# CITY OF PALM SPRINGS

### MEMORANDUM

**Subject:** **Case HSPB 52 – City National Bank (aka Bank of America) 588 S. Palm Canyon Dr**  
New screen at ATM.

Below is a comparison of the existing and proposed screens.

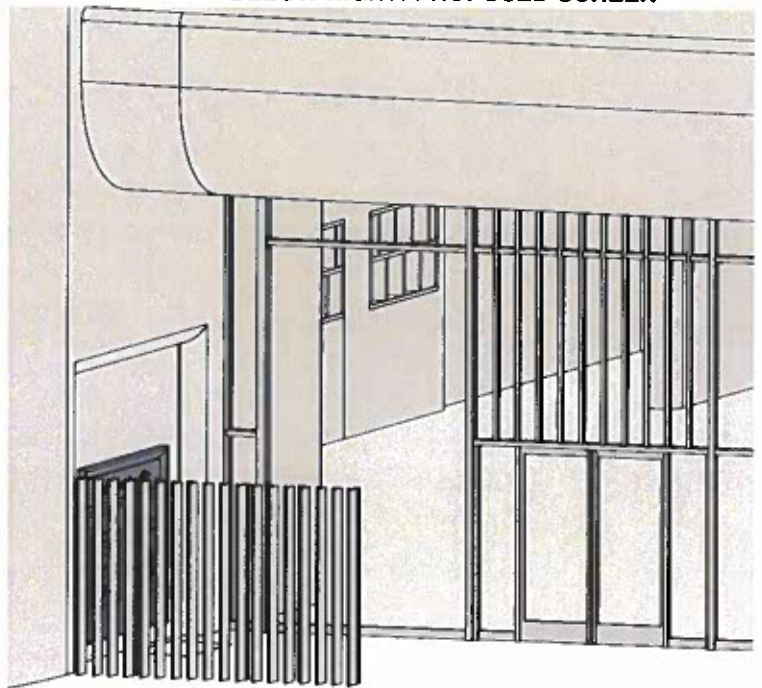
The direction I have encouraged the applicant to take with the new screen is to develop a design that is inspired by the material and finish of the vertical fins found in the original anodized aluminum storefront system along the north elevation of the bank which can be seen in the photo below.

Staff believes this proposed new screen, in a color / finish consistent with the clear finish anodized aluminum of the existing north storefront at the bank is an appropriate solution at the ATM.

ATM SCREEN ENLARGED PLAN  
SMB 3-12

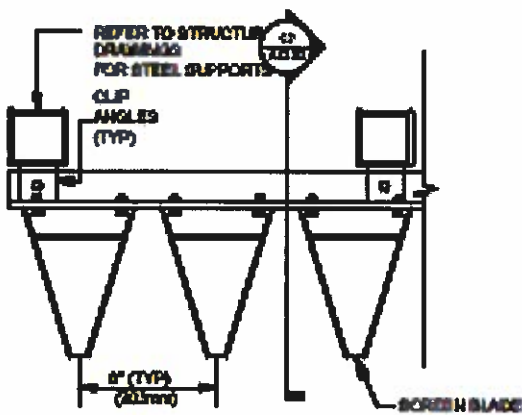
The images below are somewhat technical in nature but are included to illustrate the shape of the fins.
